The Corporation of the Municipality of Mississippi Mills

PUBLIC WORKS ADVISORY COMMITTEE AGENDA

Pakenham Pedestrian Crosswalks

Prepared by: Volunteers of the
Public Works Advisory Committee

Road Engineering Design Guidelines
10.0 Curb Extensions

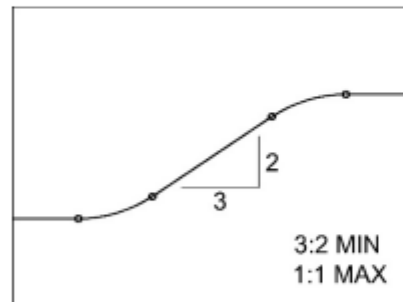
- ▶ Curb Extension Guidelines from the City of Toronto; draws into question the legitimacy of building bump outs with mountable curbs

Figure 17 – Example Curb Extension

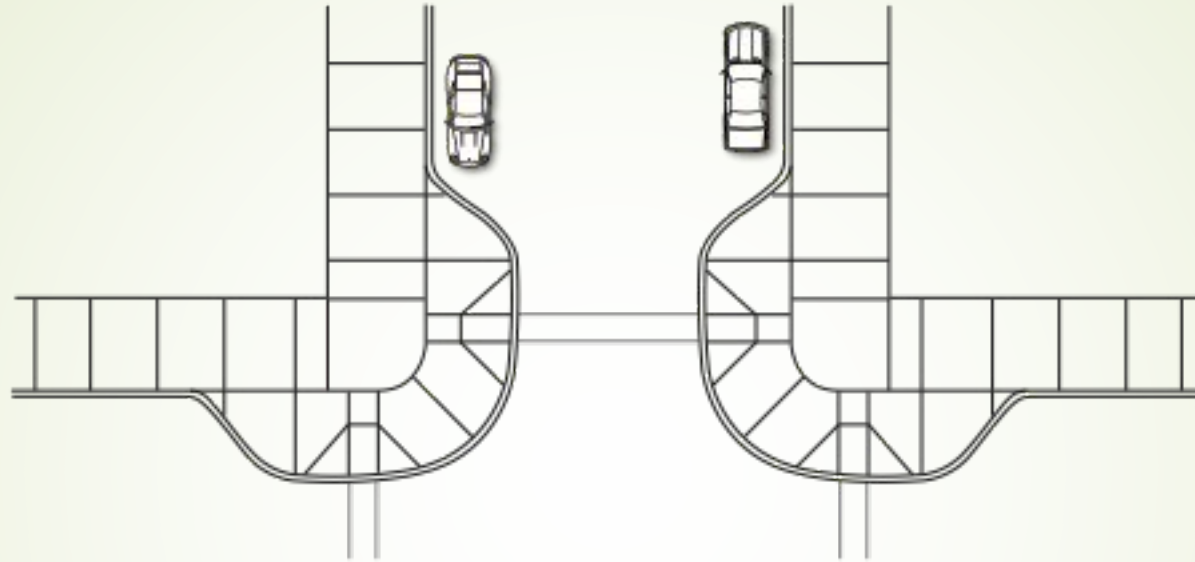
- ▶ Bump Out design was based on Ministry of Transport Pedestrian Crossings Facilities Book 15 guidelines
- ▶ page 41 clearly states that curb extensions or Bump Outs should not be used where there is concern for large vehicles driving over the pedestrian staging area; the proposed design is a direct contravention to Book 15 design standard

- The design of the crossovers was completed in accordance with OTM Book 15, which is the Provincial Standard for these types of installations. The bump-outs (curb extensions) were introduced for the added benefits outlined in Section 6.2.1.3.

- The proposal identified in the presentation for the construction of a pedestrian crossover without the bump-outs will result in a loss of parking due to the restrictions outlined in Table 11 of OTM Book 15. No loss of parking was of prime importance to the Pakenham business community and a key consideration in the approved design.
